Central Connecticut State University

REQUEST FOR QUOTATION 2017-12
Carroll Hall Verint security cameras
Addendum #1 Dated August 17, 2016

CLARENCE CARROLL HALL
20 DILORETO DRIVE
SECOND FLOOR, SECURITY PLAN

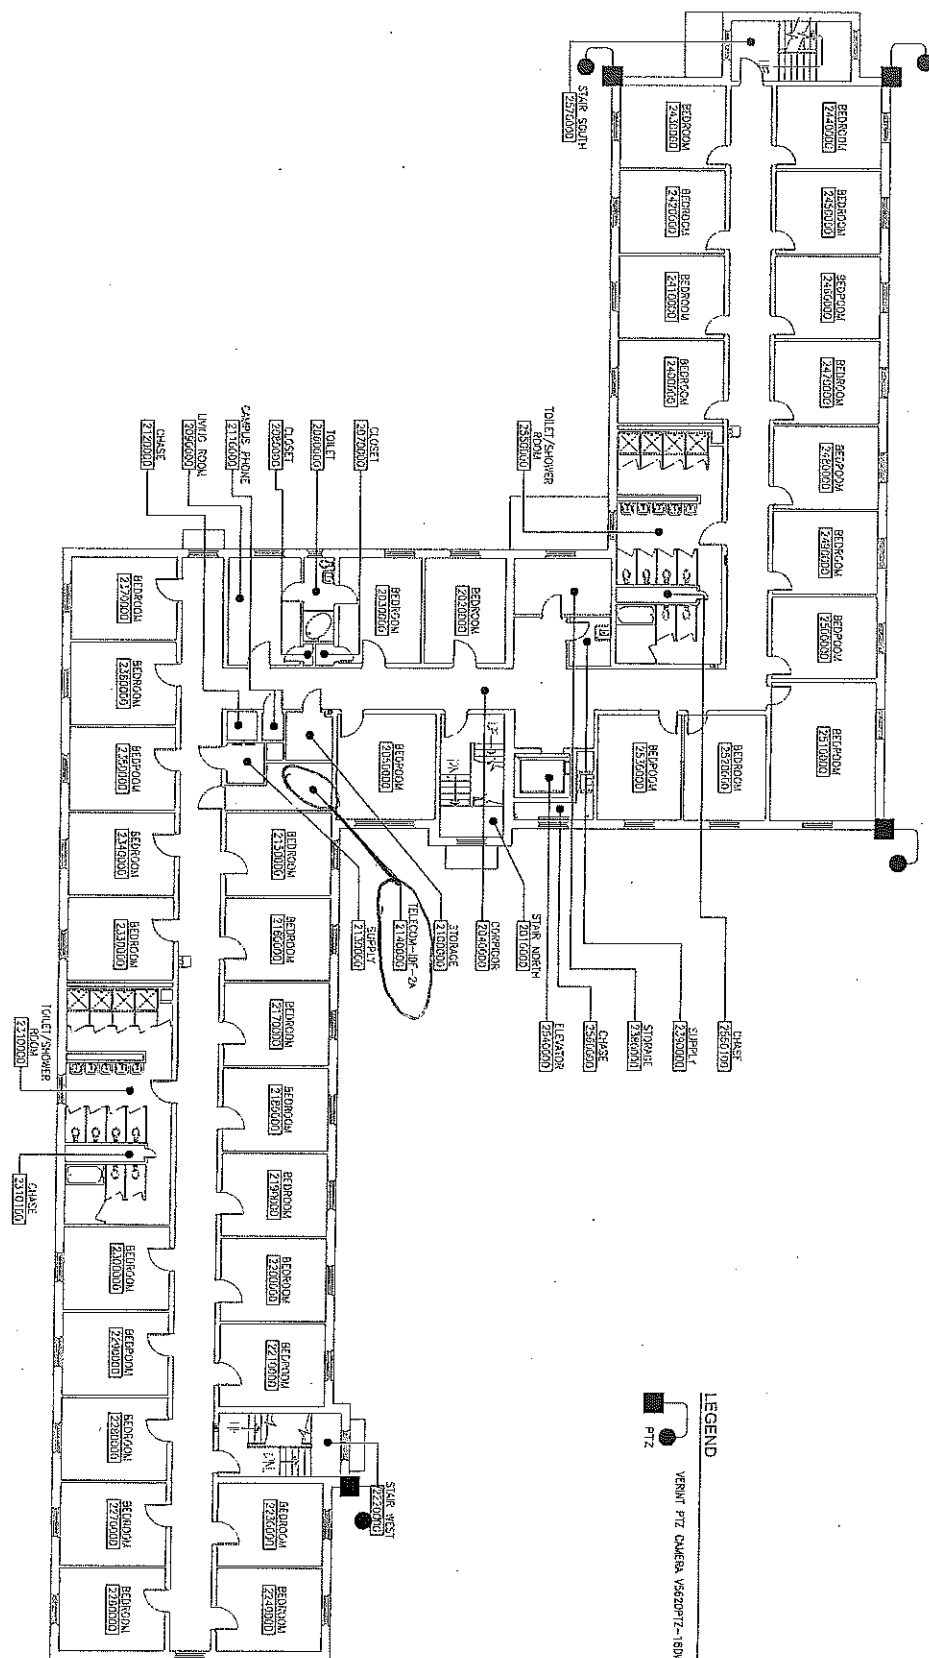
1. Is there a specified height for the (4) PTZ Cameras to be mounted?
ANSWER: Exterior of building 18FT above ground.
2. Where exactly will the network drops be located?
ANSWER: On the second floor. See revised drawing for locations.
3. If there is an IDF Room where is this located?
ANSWER: On the second floor. See revised drawing for location.
4. Can we schedule a walk through of Carroll Hall?
ANSWER: There is no walk through scheduled, however CCSU is an open, public campus. As this is mostly exterior work, interested parties may visit campus to inspect the exterior of the building. It is recommended that visitors stop at the CCSU Police Dept (1500 East Street) to obtain a parking pass first.
